PLANNING COMMISSION MEETING

August 6, 2026 - 6:00 PM
City Hall Council Chambers

To: Planning Commission
From: Kris Jenson, Planning Manager
Date: July 29, 2026
Subject: Packet Material for the August 6, 2026 Planning Commission Meeting
Agenda Item: Kenwood Hills 4th Addition preliminary and final plat, development stage plan, and easement vacation
Action Deadline: August 18, 2026

To: Planning Commission
From: Heather Botten, Senior Planner
Date: July 22, 2026
Subject: Packet Material for the August 3, 2026 Planning Commission Meeting
Agenda Item: Highview Preliminary Plat
Action Deadline: August 31, 2026

EXHIBIT G

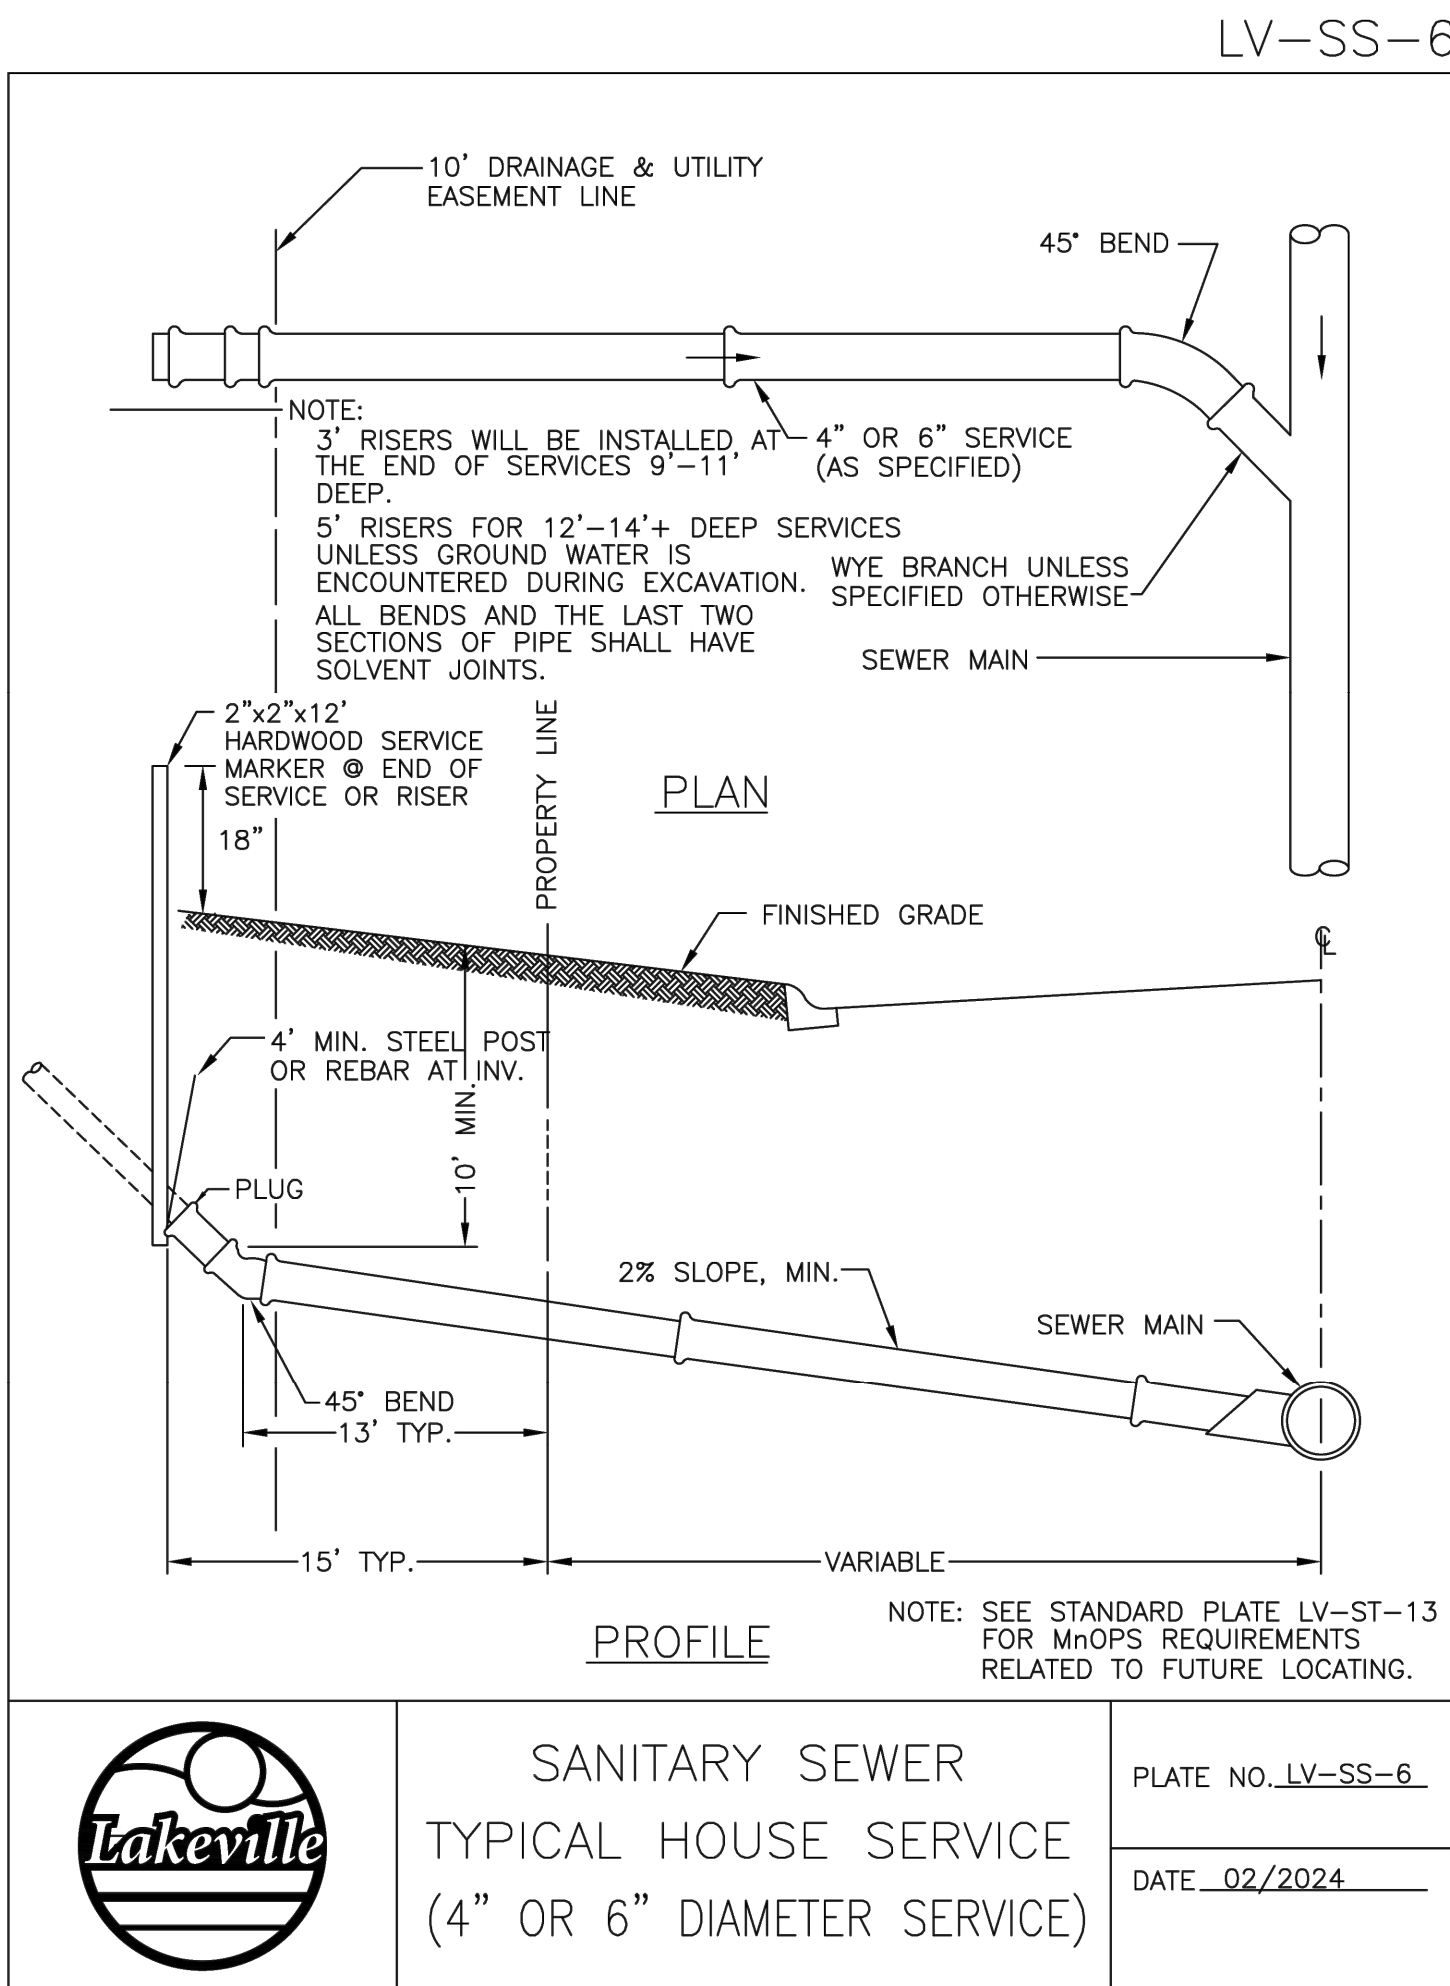
Prior to City Council consideration of the preliminary and final plat, a notation must be added to the grading plat that there are no significant trees within the limits of construction.

The final grading plan shall identify all fill lots in which the building footings will be placed on fill material. The grading specifications shall also indicate that all embankments meet FHA/HUD 79G specifications. The Developer must certify to the City that all lots with footings placed on fill material are appropriately constructed. Building permits will not be issued until a soils report and an as-built certified grading plan have been submitted and approved by City staff.
